Re: 339 West Gorham Street: Oliv Madison

Attached is a minor amendment packet for the Oliv Madison Project. These changes address some program elements (expanded amenity), design refinements, and adding solar to the project. The packet illustrates the changes between the Original SIP document and the proposed amendments. The site plan review/building permit set elevations are also included for reference to show what was approved with the building permit.

UDC MINOR REVISIONS

OLIV MADISON 339 W GORHAM STREET

A14

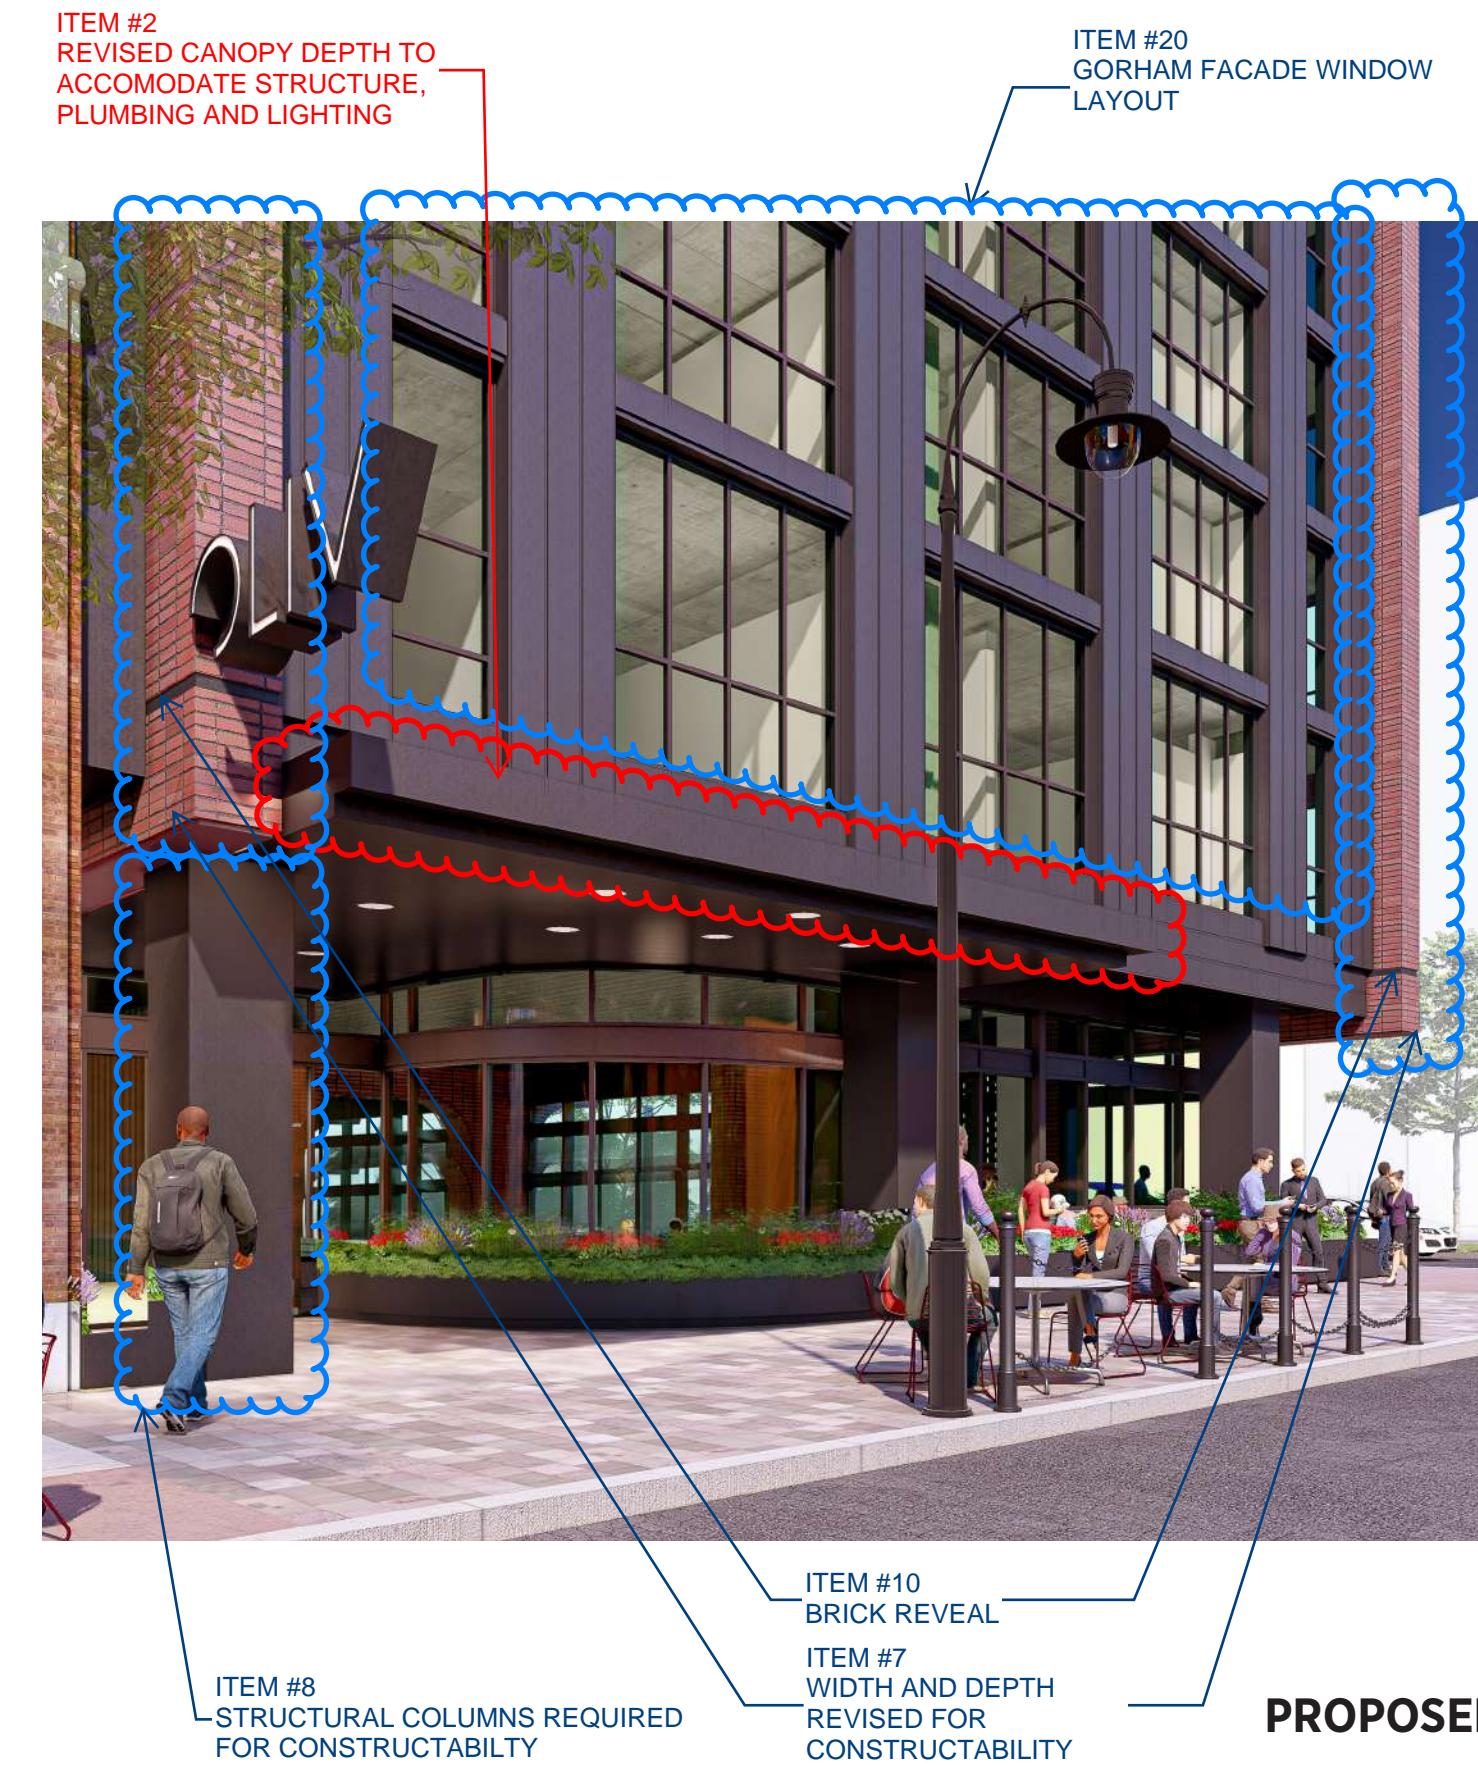
- Item 1. Curved Steel Elements (A14, A17, A7, A10): Revision from brick to painted steel plate for the curved elements adjacent to the lobby. This was done for constructability.

- Item 2. Front Entry Canopy (A14, A17, A7, A17, A18): Revise proposed entrance canopy for constructability. The thickness of the canopy needs to be 14" in order to fit structure, light fixtures and roof drain bodies.

Item 7. Architectural Brick Pier (A14, A17, A18): Width and depth revised for constructability.

Item 8. Structural Columns (A14, A17): Structural columns required for constructability.

Item 9. Brick Screen Wall (A14): Adjustments to screen wall for lateral bracing, constructability and maintenance.

ITEM #7
WIDTH AND DEPTH
REVISED FOR
CONSTRUCTABILITY

A15

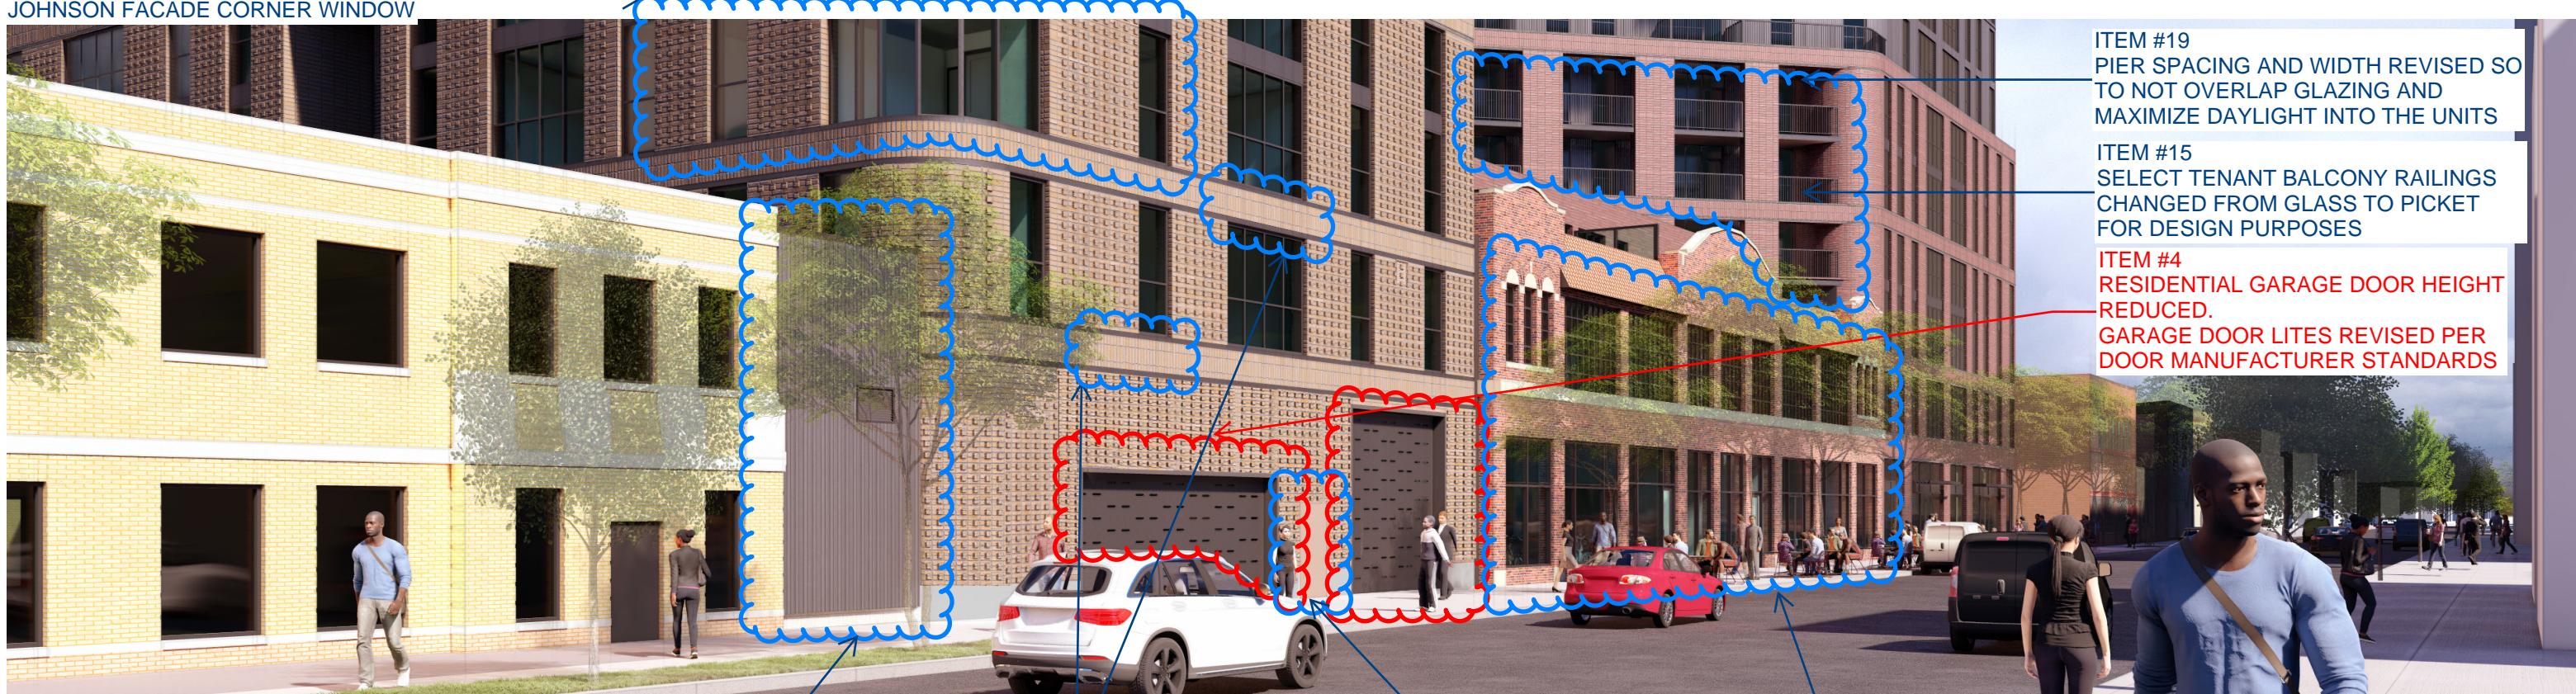
- Item 3. Retail Storefront Canopies (A15, A42): Revise retail storefront awnings to aluminum louvered canopies.
- Item 4. Residential Garage Door Height (A19, A13): Residential garage door height reduced; brick added. Garage door lites revised per door manufacturer standards.

Item 13. Parapet Walls (A15, A16, A4, A7, A10, A13): Parapets increased in height to accommodate required roof sloping, drainage and waterproofing.

Item 26. Gorham Street Metal Band (A15, A7): Deeper metal band for constructability.

A7

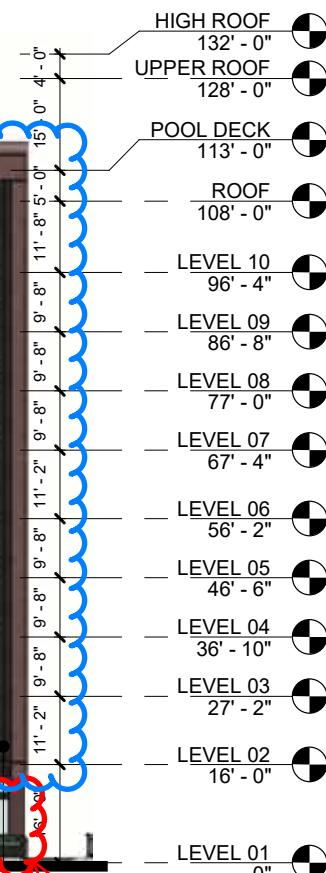
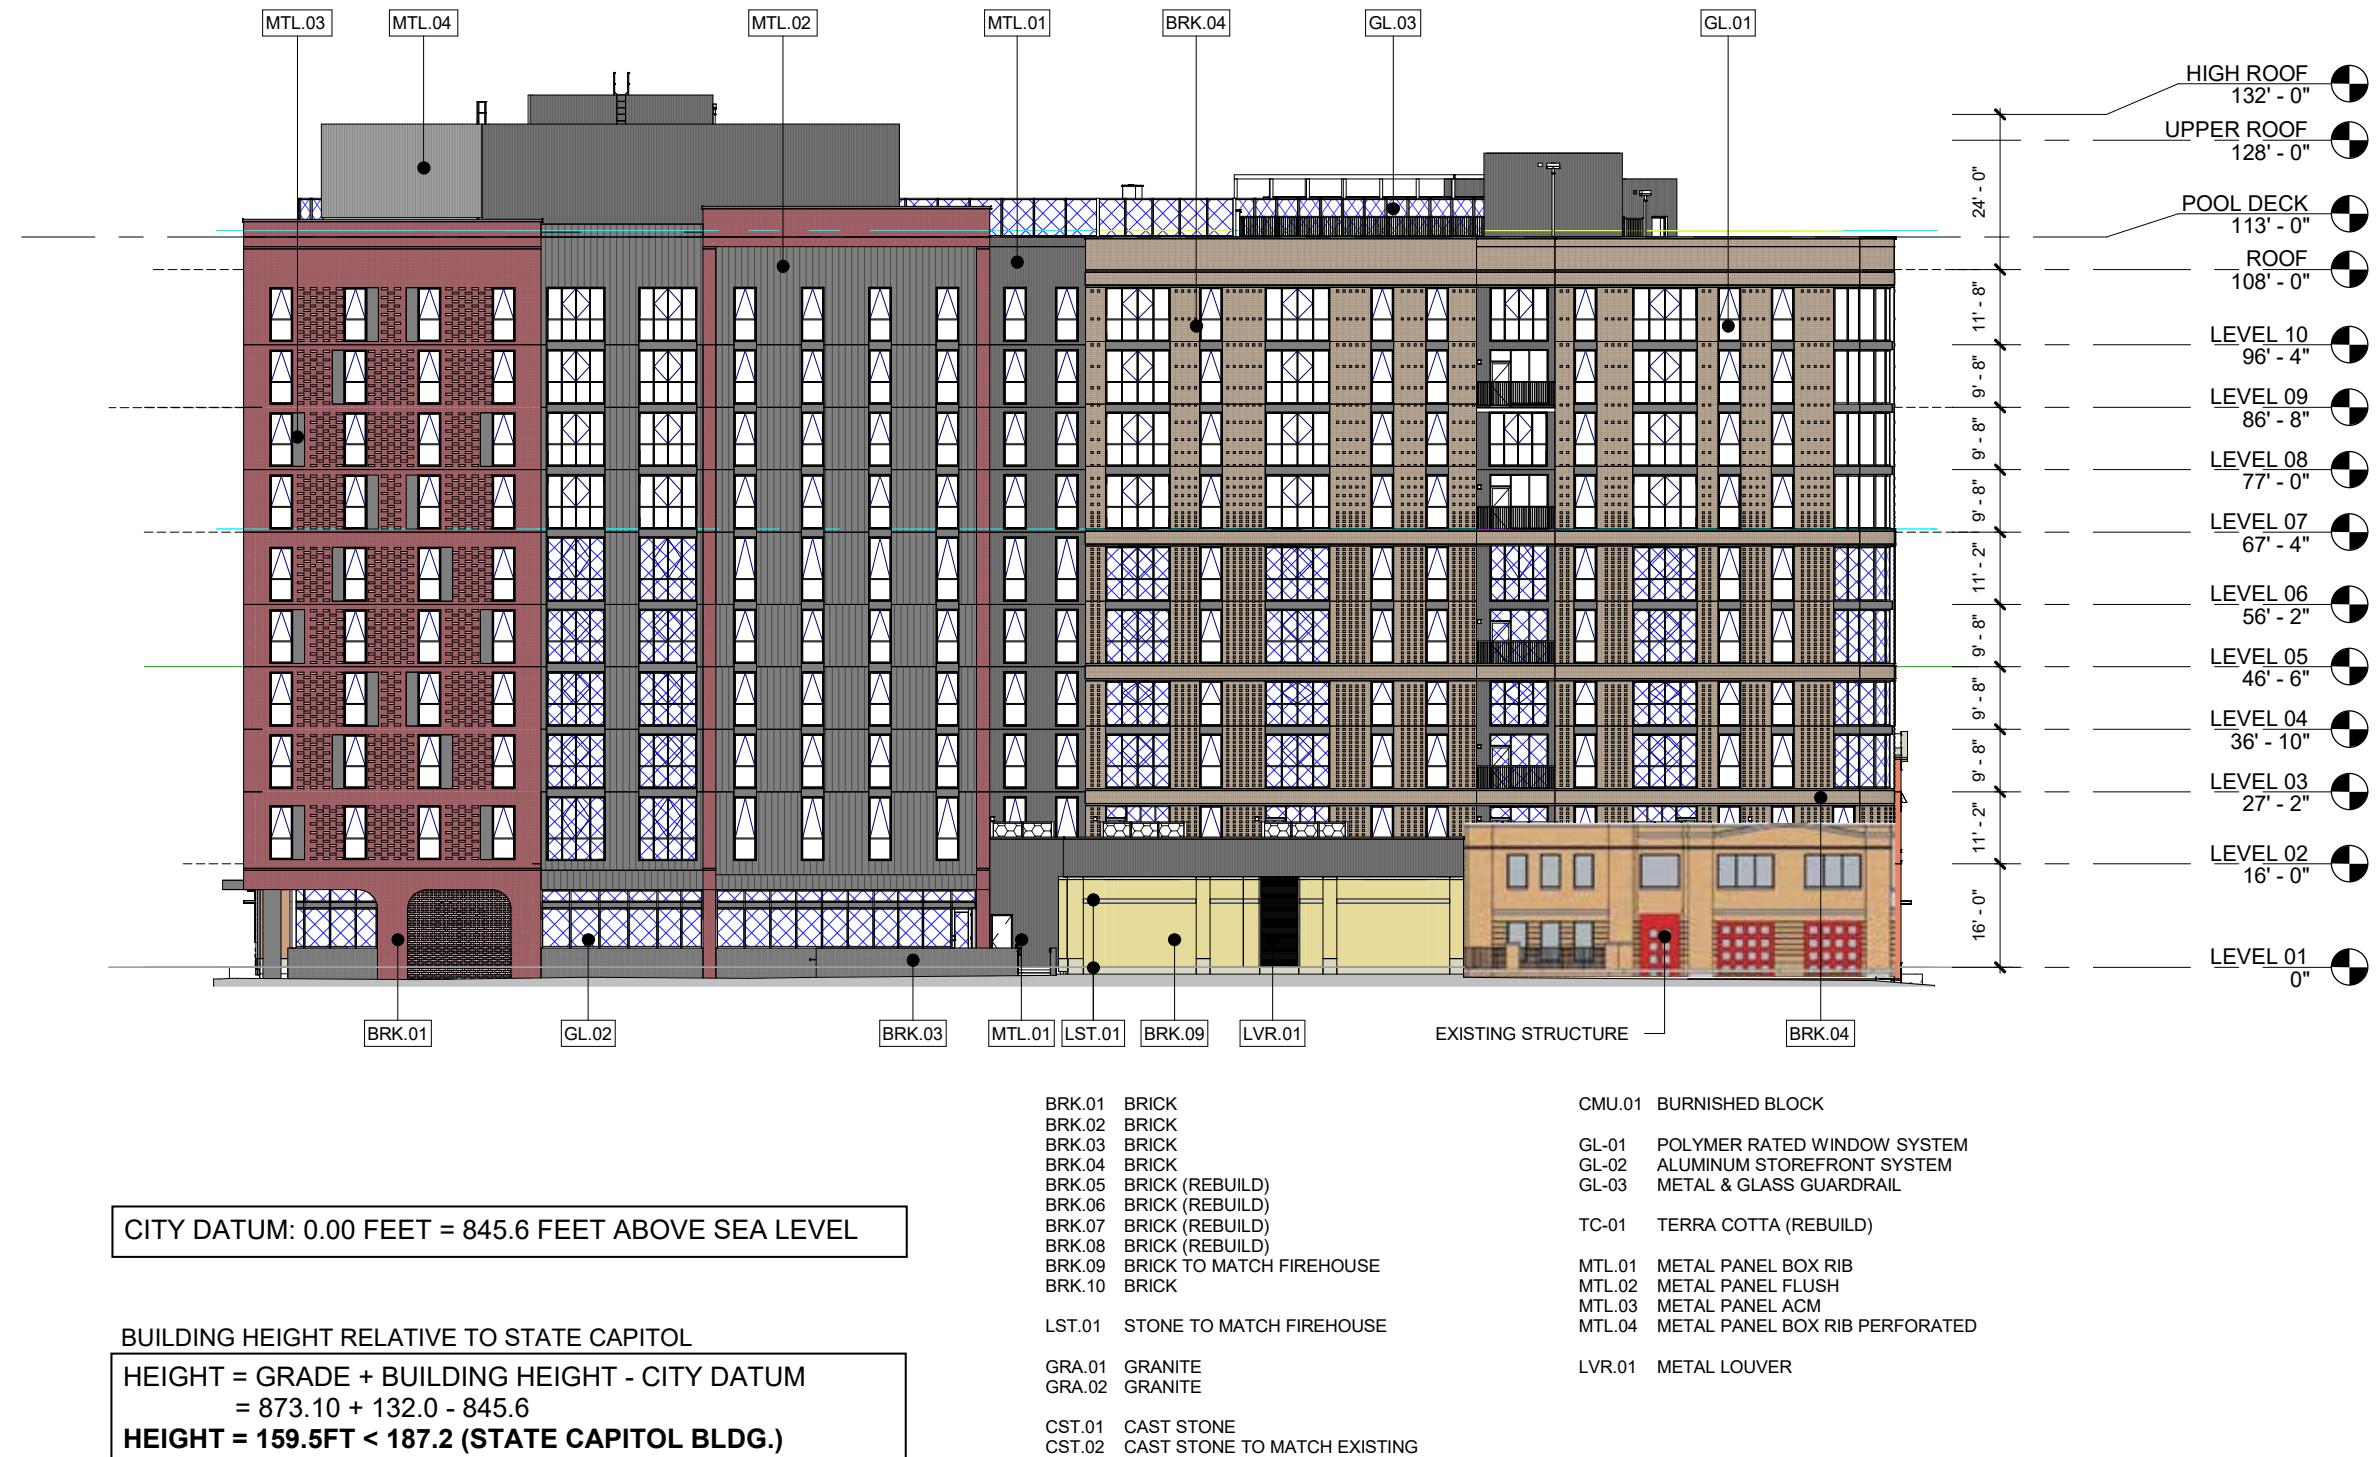
ITEM #28
WINDOW SPACING ADJUSTED TO ALIGN WITH
UNIT LAYOUTS - TYPICAL ON ALL FACADES

ITEM #27
GLASS RAILING DEVELOPED FURTHER
THOUGHOUT BUILDING - TYPICAL ON ALL
FACADES

ITEM #15
SELECT TENANT BALCONY RAILINGS
CHANGED FROM GLASS TO PICKET
FOR DESIGN PURPOSES

ITEM #20
GORHAM FACADE WINDOW
LAYOUT

ITEM #3
PROPOSING ALUMINUM
LOUVERED CANOPIES AT
RETAIL STOREFRONTS.

ITEM #13
PARAPETS INCREASED IN
HEIGHT TO ACCOMODATE
REQUIRED ROOF ASSEMBLY

ITEM #26
DEEPER METAL BAND FOR
CONSTRUCTABILITY

ITEM #1
PAINTED STEEL PLATE FOR
CONSTRUCTABILITY
ITEM #2
CANOPY REVISED FOR
CONSTRUCTABILITY
ITEM #1
PAINTED STEEL PLATE FOR
CONSTRUCTABILITY
ITEM #3
PROPOSING ALUMINUM
LOUVERED CANOPIES AT
RETAIL STOREFRONTS.

A10

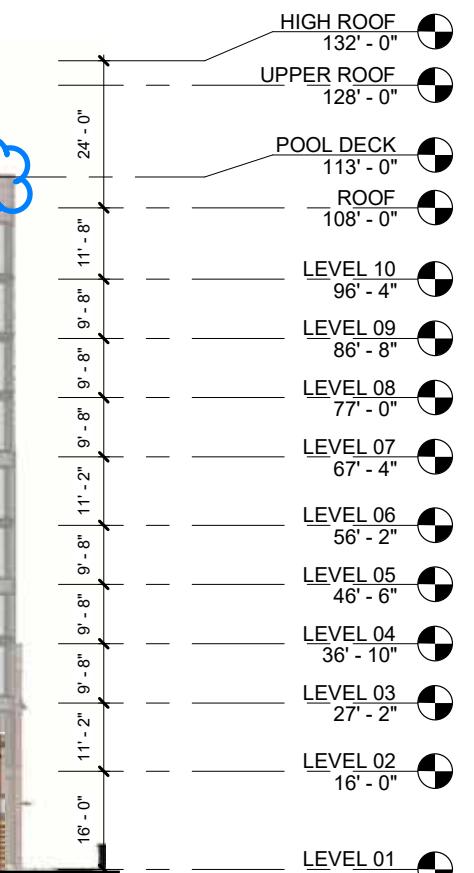
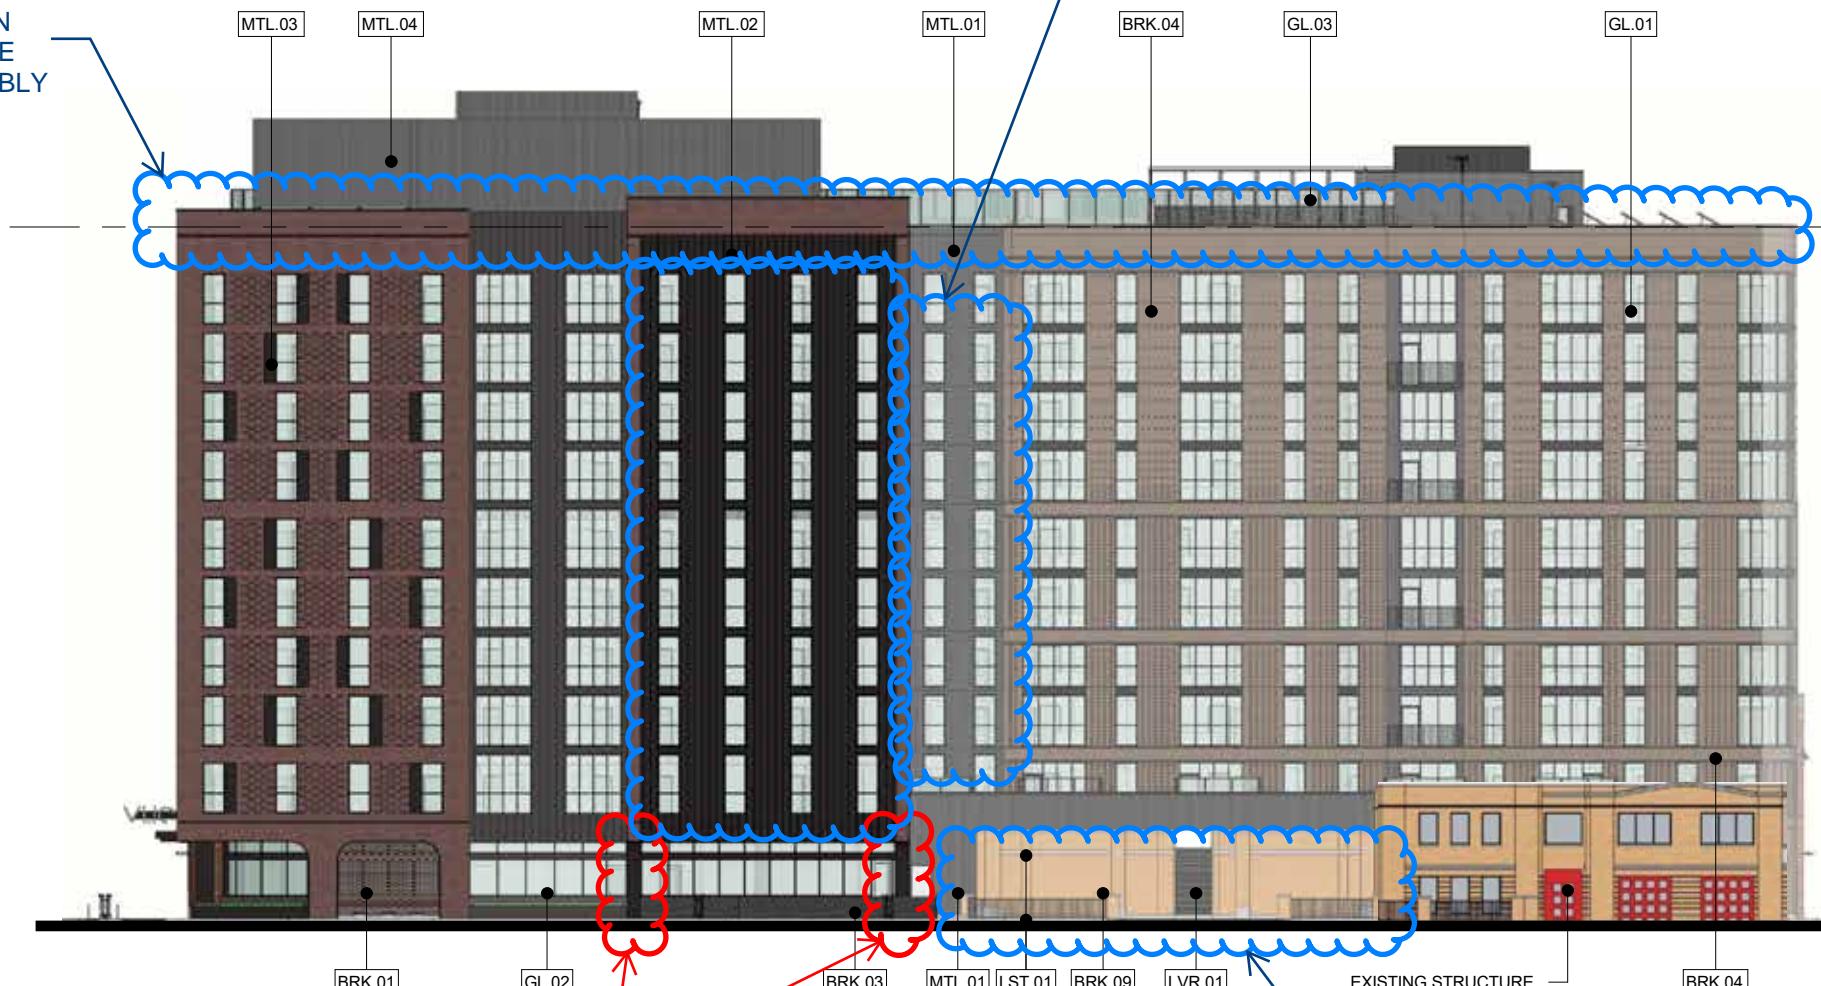
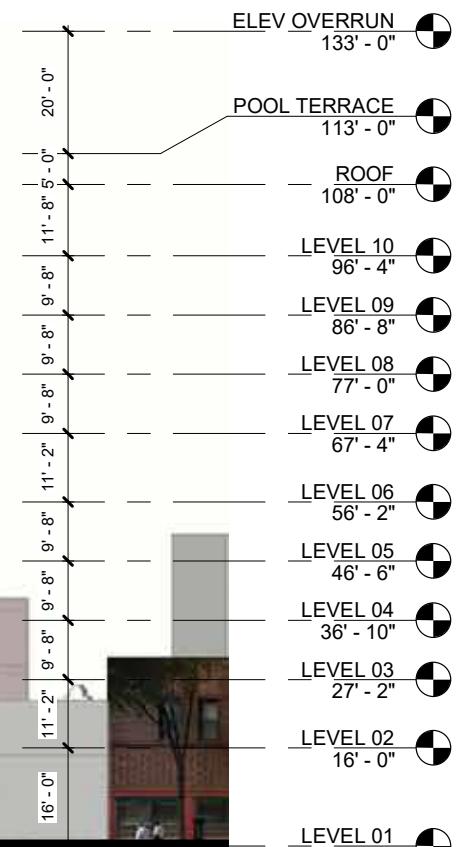
ITEM #28
WINDOW SPACING ADJUSTED TO ALIGN WITH
UNIT LAYOUTS - TYPICAL ON ALL FACADES

ITEM #10
BLACK BRICK
REVEAL

ITEM #27
GLASS RAILING DEVELOPED FURTHER
THOUGHOUT BUILDING - TYPICAL ON ALL
FACADES

ITEM #13
PARAPETS INCREASED IN
HEIGHT TO ACCOMODATE
REQUIRED ROOF ASSEMBLY

ITEM #22
BALCONIES REMOVED
PER UNIT LAYOUT

ITEM #1
PAINTED STEEL PLATE FOR
CONSTRUCTABILITY

ITEM #21
METAL PANEL CHANGED TO BRICK THAT
MATCHES FIREHOUSE BRICK
